U.S. Department of the Interior BUREAU OF LAND MANAGEMENT

Sundry Print Reports

Well Name: SMITH FED GAS C Well Location: T22S / R23E / SEC 12 / County or Parish/State: EDDY /

Notice of Intent

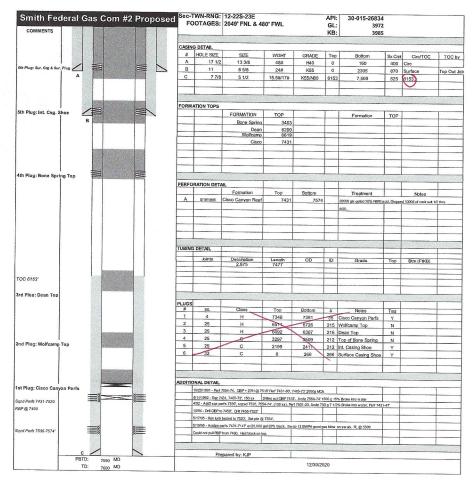
- 1. MIRU all safety equipment as needed. NU BOP. POOH with production equipment.
- Set a CIBP at 7381 ft with 35 ft Class H cement on top to 7346 ft. This will cover Cisco Canyon 2. leak test CIBP, Must Use Bailer 6726 600' perfs. WOC and tag. 7440

- 3. Spot a 25 sx Class H cement plug from 6726 ft - 6511 ft. This will cover top Wolfcamp.
- Spot a 25 sx Class H cement plug from 6307 ft 6092 ft. This will cover top Dean. 4.

- Perforate at 3509 ft. Spot a 25 sx Class C cement plug from 3509 ft 3297 ft. This will cover top Perforate at 2411 ft. Spot a 25 sx Class C cement plug from 2411 ft – 2199 ft. This will cover 8-Bone Spring. WOC ETHE

- 5/8 inch casing shoe. WOC and tag. 60 5%
- Perforate at 266 ft. Spot a 32 sx Class C cement plug from 266 ft up to surface. Back fill as 7. needed. (In/out) Verify @ surface.
